TRUCK MEDIUM MC2 (UNIMOG) - ALL TYPES
ACCELERATOR PEDAL STOP BOLT

MODIFICATION INSTRUCTION

FIG 1 - STOP BOLT BRACKET ASSEMBLY

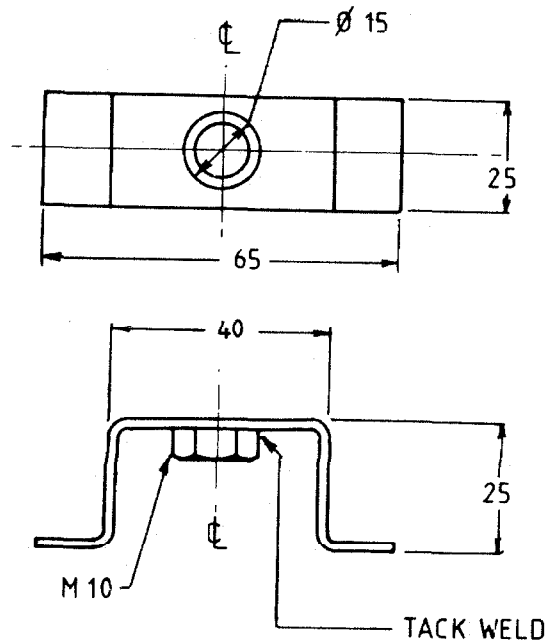
- b. Manufacture the stop bolt bracket as shown in Fig 1 using Table 1, items 1 and 3.
- c. Weld the stop bolt bracket to the accelerator pedal as shown in Fig 2.
- d. Paint the modified pedal assembly in accordance with WKSP B 700.
- e. Fit the bolt and locknut (Table 1, items 2 and 3) to the stop bolt bracket as shown in Fig 3.
- f. Refit the modified accelerator pedal assembly to the truck.
- g. Adjust the stop bolt assembly to achieve 10mm clearance between the head of the stop bolt and the cab floor with pedal in full fuel position.

FIG 3 - COMPLETED MODIFICATION

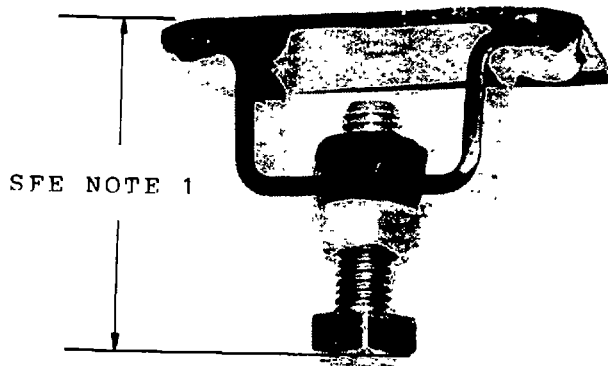
- 1. If the stop bolt head to pedal dimension as shown in Fig 3 is considerably less than 50mm, the throttle linkages are either bent or incorrectly adjusted and rectification action must be carried out.
